International Expert Review of SR-Can: Engineered Barrier Issues

External review contribution in support of SKI's and SSI's review of SR-Can

March 2008

Figure 3: Illustration of SKB's revised concept for backfilling of waste deposition tunnels. From Gunnarsson (2007).

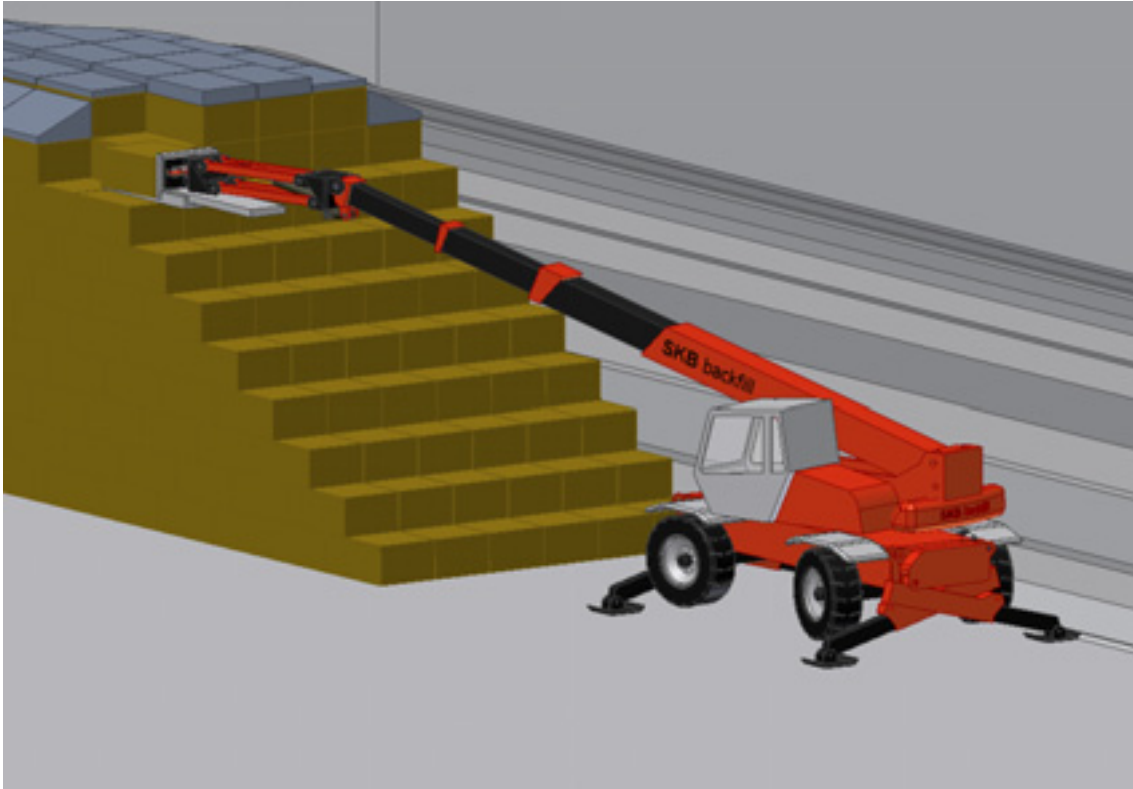
Second, with regard to the details of the preferred backfilling concept (pre-formed clay blocks and bentonite pellets), the review group notes that the concept was developed for use with drill and blast tunnel excavation techniques (SKB, 2002) and that it may have to be redesigned (e.g. in terms of block geometry, stacking pattern and installation equipment) if a decision was made to use a tunnel boring machine. The review group also notes that SKB has not yet defined or proposed in detail how it would go about backfilling other repository cavities such as shafts (see SKB, 2006f, page 93).

The topics of demonstrating the feasibility of EBS fabrication and emplacement, and erosion of backfill are addressed in more detail below, but the review group considers that it will be essential for SKB to demonstrate that the backfill can be emplaced successfully at the rates of emplacement that will be required in the repository and given realistic groundwater inflow rates through fractures. One concern is that piping of backfill by inflowing groundwaters during the operational period could slow backfill emplacement operations and possibly result in a backfill with a final density lower than required.

Figure 1 Saturation time of Friedland backfill as a function of fracture spacing and transmissivity

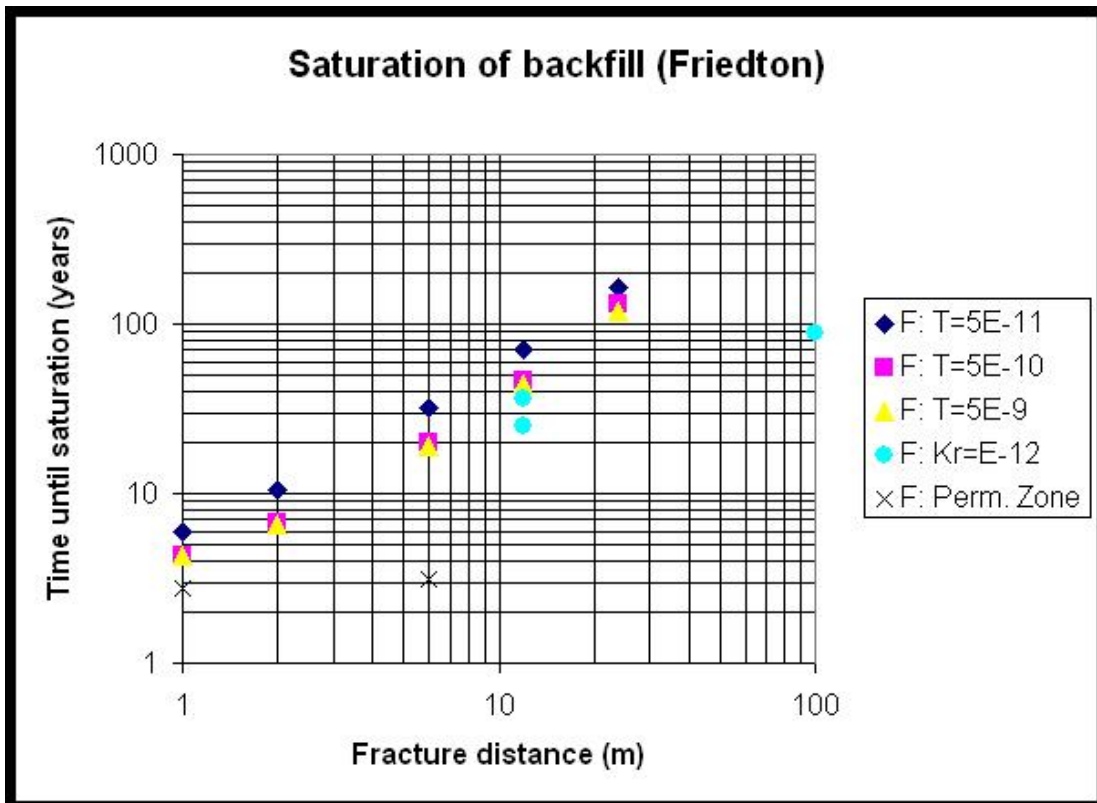
h) How do expected rates of backfill re-saturation relate to fractures in the host rock, how variable might backfill re-saturation be? What factors, including potentially adverse impacts, determine the amount of variation in re-saturation that can be accommodated and how much variation can be accommodated?

This is presented in SR-Can and in more detail in /Börgesson et al SKB TR-06-14/. Figure 1 shows the saturation time for the Friedland backfill as a function of fracture spacing and transmissivity. The saturation time will most likely vary from a few years to a few hundred years in different parts of the repository. Backfill saturation time is not seen as a critical issue for repository performance.

Figure 2 Coffee table experiments, where bentonite is expanding out into a slowly flowing water in a artificial fracture between two plexiglass plates

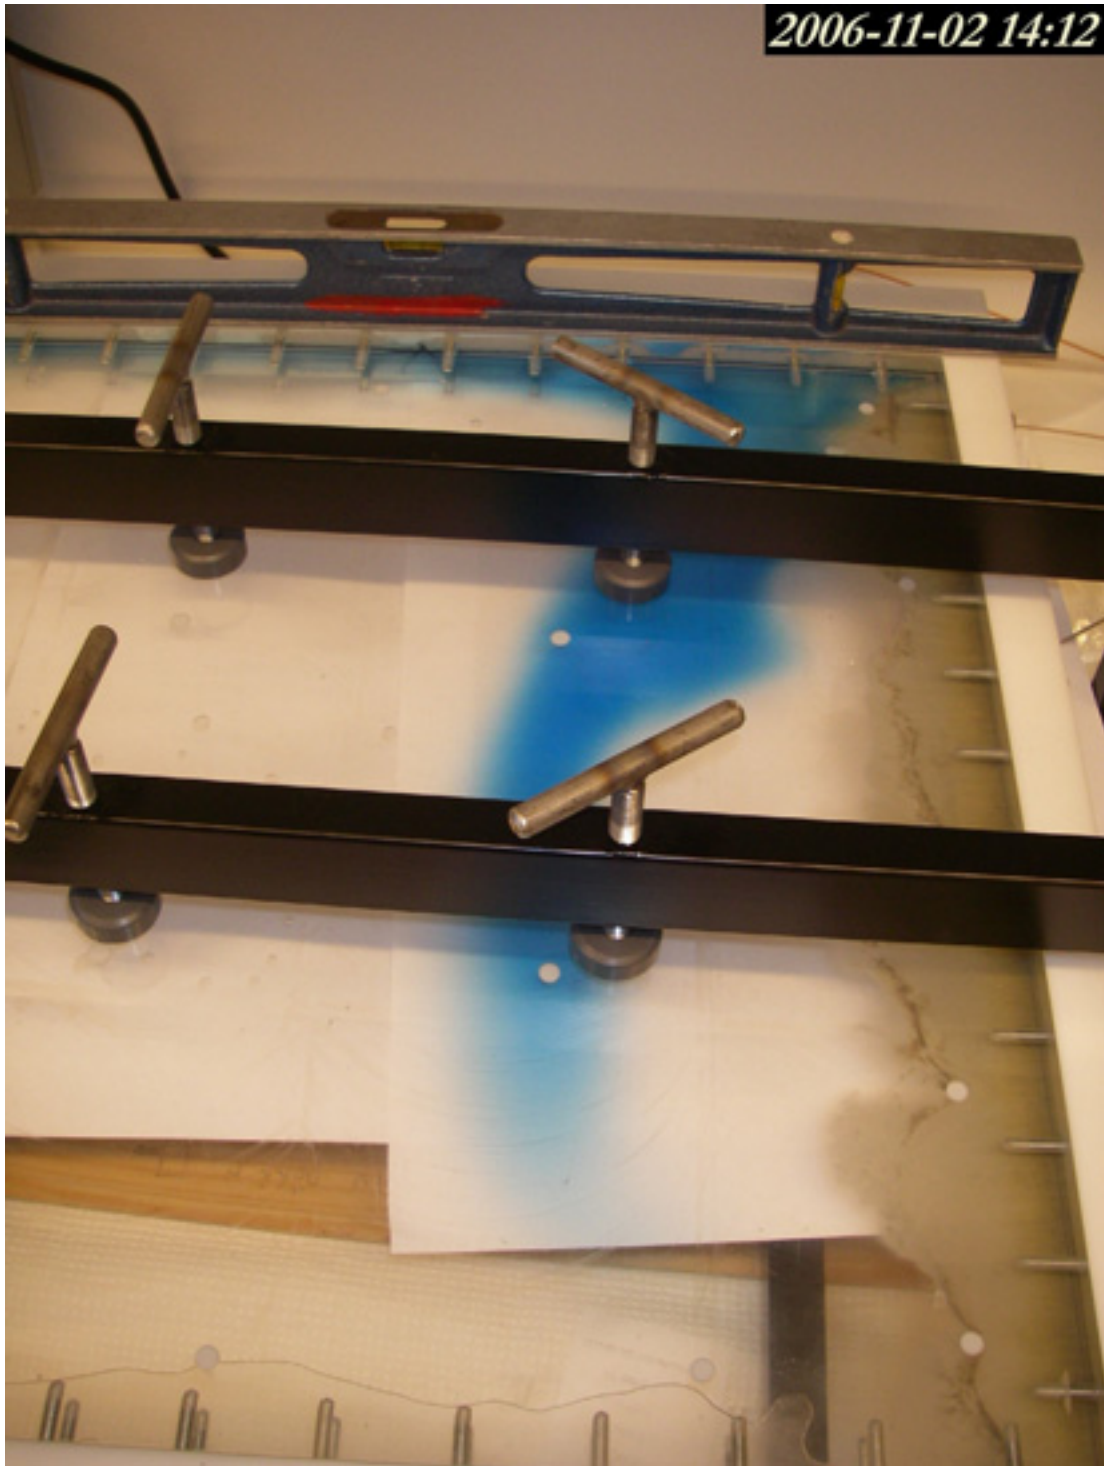
- d) In detail, what further experiments are planned on piping and erosion?**

The piping process is studied in medium-large scale experiments in the KBS-3H and Baclo projects.

The colloid formation process is studied within the Bentonite Erosion project. This project includes an extensive range of experiments, among them the coffee table type (Figure 2).

Figure 1. The case in Figure 10-42 of TR-06-09 extended to 10^9 years.

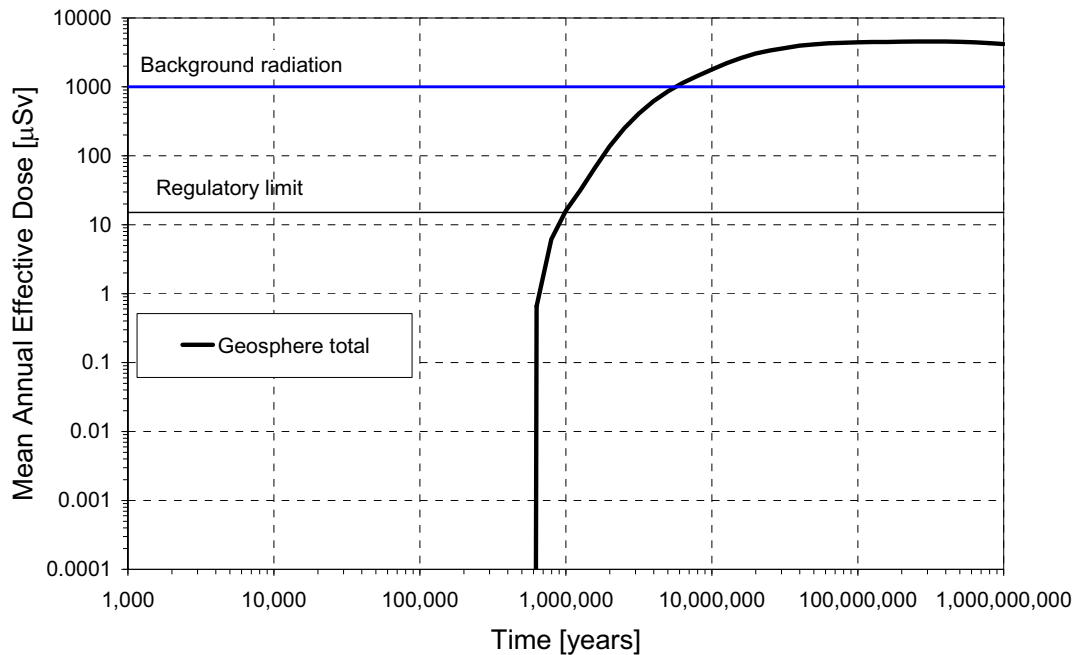
g) What is the peak dose rate for a given scenario/ variant case?

This has been calculated for the Forsmark advection/corrosion base case, i.e. the case presented in Figure 10-42 has been extended, as a response to this question, see the below figure. The peak calculated dose is around 4 mSv, i.e. about four times the background radiation. For the extended calculation, it is simply assumed that canister corrosion and fuel alteration continues at the same rates as in the one million year timeframe and that the transport properties of the host rock are not altered. Probabilistic calculation, 10,000 realisations, analytical model.
